Department of Energy
Washington, D.C. 20545

Docket No. 50-537
HQ:S:82:045

RESPONSES TO REQUEST FOR ADDITIONAL INFORMATION - GEOLOGY AND SEISMOLOGY

Reference: Letter, P.S. Check to J. R. Longenecker, "CRBRP Request for
Additional Information," dated April 9, 1982

figure 25-18, sheet 1 of 4

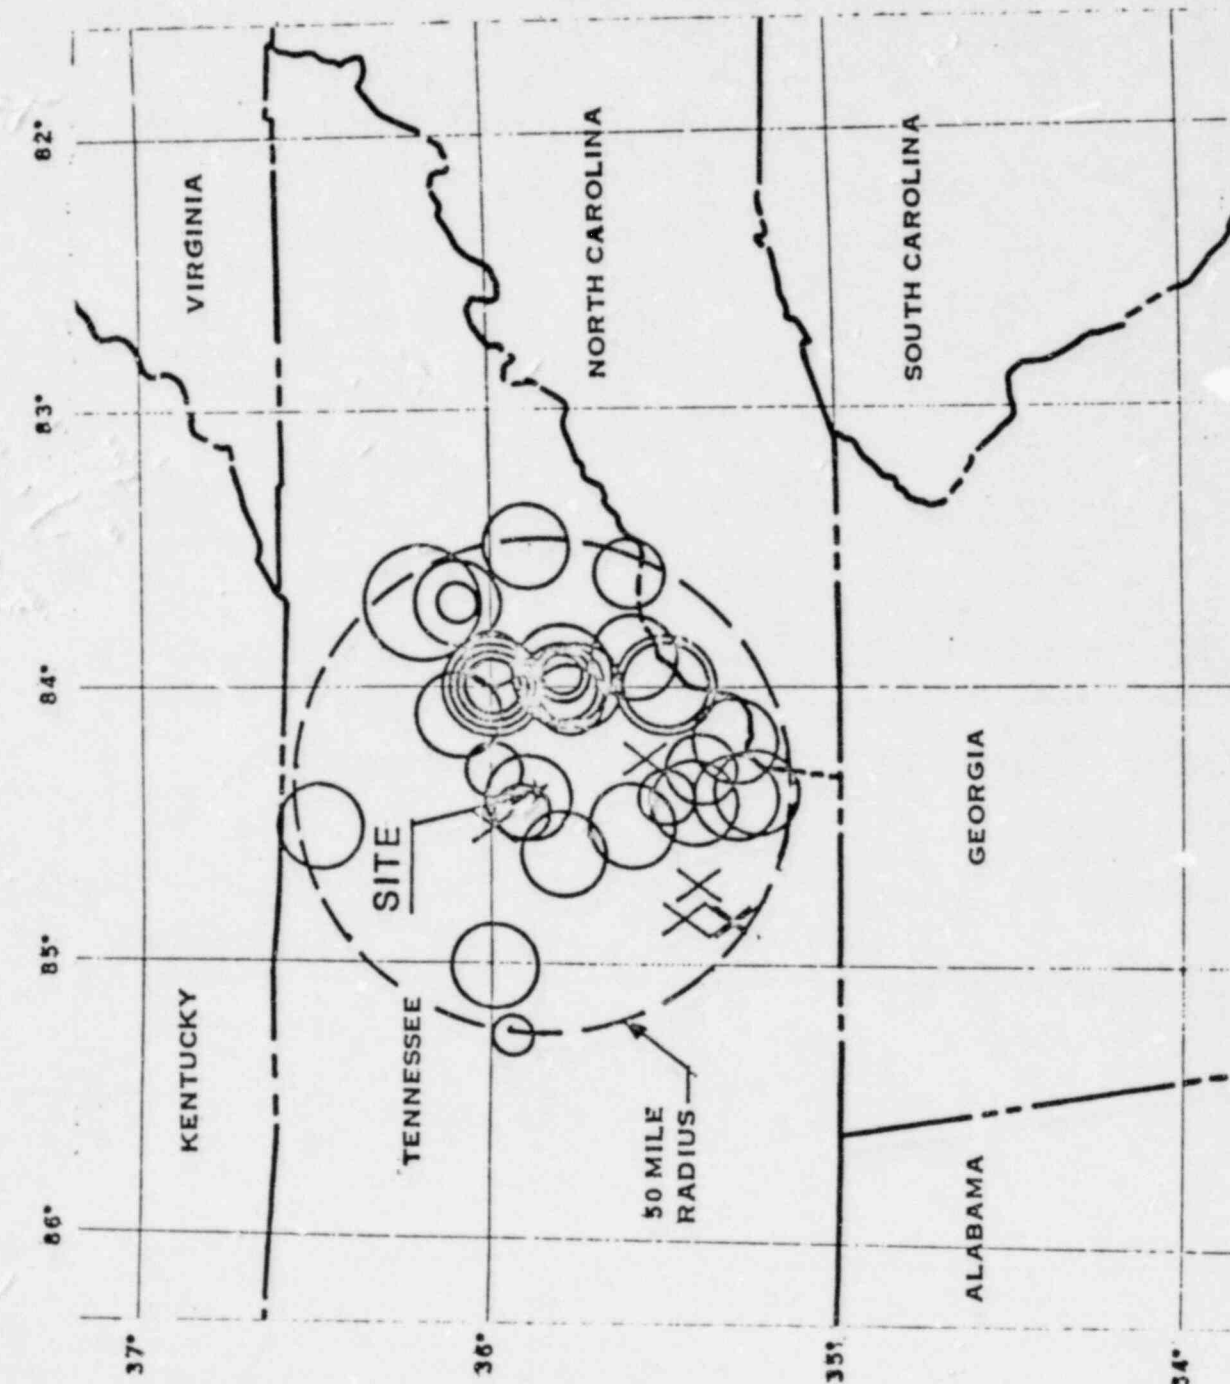
The last earthquake listed in both Table 2.5-2 and Table 2.5-3 of the PSAR is dated November 30, 1973. Update both of these seismicity lists to include all more recent pertinent events. Include in Table 2.5-3 all earthquakes of maximum Modified Mercalli Intensity greater than IV or magnitude greater than 3 which have been reported in all tectonic provinces any parts of which are within 200 miles of the site. Where available, for each earthquake provide epicenter coordinates, depth of focus, origin time, highest intensity, magnitude, seismic moment, source mechanism, source dimensions, source rise time, rupture velocity, total dislocation, fractional stress drop and any strong motion recordings; references from which the specified information was obtained should be identified. All magnitude designations such as m_b , M_L , M_S , etc. should be identified. The epicenters of all earthquakes listed in Table 2.5-3 should be plotted on a map such as Figure 2.5-8. Provide a larger scale map showing earthquake epicenters of all known events within 50 miles of the site.

Figure 2.5-18, sheet 1 of 4 shows all earthquakes with maximum intensities exceeding IV MM and/or magnitudes equal to or greater than 3.0, reported within the geographic region 30° - 41.5° N latitude; 73.5° - 93° W longitude. The open circles indicate all events with intensities exceeding IV MM. The X's represent those events (Magnitude greater than or equal to 3.0) which were either unfelt or had reported intensities of IV MM or less. The X's also include several significant early historical events with unreported magnitudes and intensities.

FIGURE 2-5

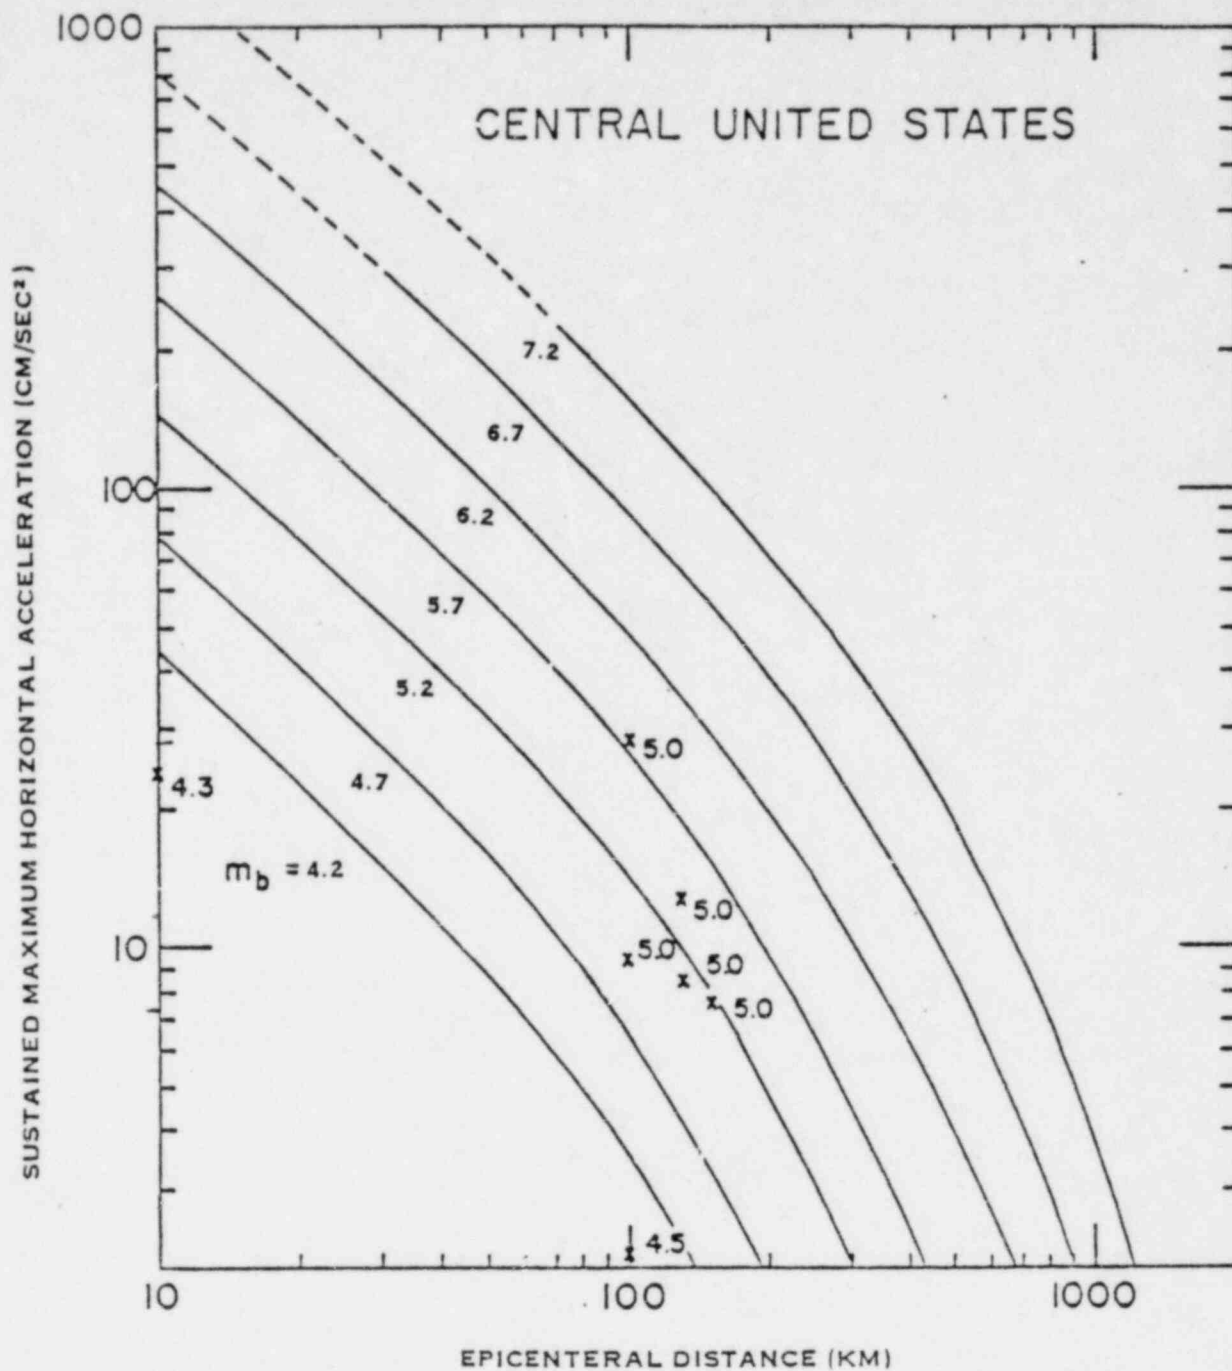
- a) The potential of the 1897 earthquake being associated with this specific geologic structure;
- b) The potential of an earthquake up to $M_s = 7.0$ located in Giles County, and any far field ground motion effect^s (both peak value and response spectrum) at the site from an $M_s = 7.0$ event located in Giles county.
- c) The potential of similar seismicogenic structures being located near the Clinch River site, and any effects at the site from earthquakes on these seismicogenic structures.

Under the assumption that the hypocenters define a single fault plane, the fault plane area is estimated by arbitrarily moving the hypocenters toward or away from their centroid. This is illustrated in Figure 2-5. This results in a range of fault plane area of 80 to 800 km².
